Office Action Summary

10/505,408

DETAILED ACTION

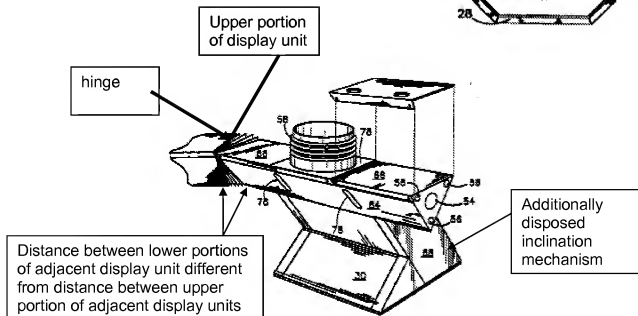
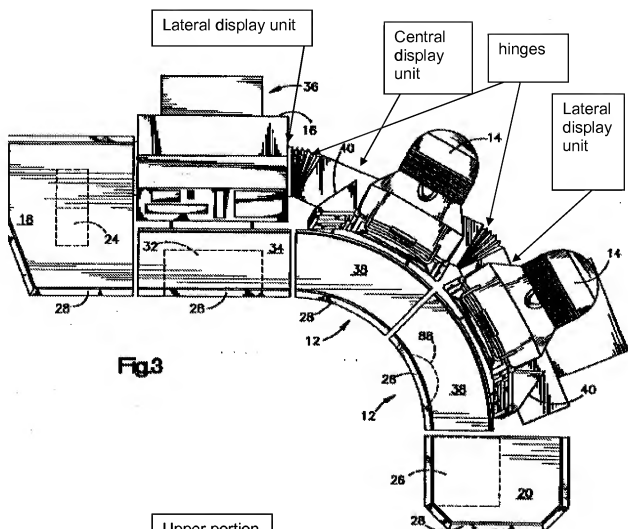
Claims 1 and 3 as best understood are rejected under 35 U.S.C. 103(a) as being unpatentable over Fowler et al (US patent no. 6,302,612) in view of Bonar (US patent no. 4,233,708). Fowler discloses a multi-display device, wherein a plurality of basic displays or basic units are horizontally arranged, a central basic display or central basic unit (131) is supported and held in an inclined state by an additionally disposed inclination mechanism (the ball underneath central screen 131 connected to the keyboard), lateral basic displays or lateral basic units (148) are connected to the central basic display or central basic unit (131) respectively by hinge members (ball and socket joint 147) so that a distance between the adjacent basic displays or basic units at an upper side portion of the basic display or basic unit is different from one at a lower side portion (the universal joint 147 of Fowler permits such distance to be different). However, Fowler does not disclose the connection using the hinge member having a shaft and an upper side connection portion and a lower side connection portion are different from each other and are integrated in one hinge. Such hinge connection is old and well-known. Bonar teaches such connection using the hinge member having a shaft (23, 31, figure 4) and an upper side connection portion (11) and a lower side connection portion (9) are different from each other and are integrated in one hinge. It would have been obvious to one of ordinary skill in the art to have modify the hinge of Fowler with the hinge of the type shown by Bonar. Such modification would have involved a mere substitution of one well-known type of hinge for another which is well within the ambit of one of ordinary skilled in the art.

Claims 1 and 3, as best understood are rejected under 35 U.S.C. 103(a) as being unpatentable over Maguire, Jr. (US patent no. 5,416,666) in view of Bonar (US patent no. 4,233,708). Maguire discloses a multi-display device having all the claimed features of applicant's invention as illustrated below. However, Maguire does not disclose the connection using the hinge member having a shaft and an upper side connection portion and a lower side connection portion are different from each other and are integrated in one hinge. Such hinge connection is old and well-known. Bonar teaches such connection using the hinge member having a king-pin (23, 31, figure 4) and an upper side connection portion (11) and a lower side connection portion (9) are different from each other and are integrated in one hinge. It would have been obvious to one of ordinary skill in the art to have modify the hinge of Maguire with the hinge of the type shown by Bonar. Such modification would have involved a mere substitution of one well-known type of hinge for another which is well within the ambit of one or ordinary skilled in the art.

Applicant's arguments filed 1/26/2009 have been fully considered but they are not persuasive. Applicant's argues that Fowler or Maguire, Jr. does not a king-pin free from the displays or basic units. Applicant's claim language does not a king-pin with upper and lower leaves. Bonar does show his hinge members (11 and 17) each have pins (23, 31, figure 4) with different distances from the connection (34, 35) on the leaves (11 and 17).
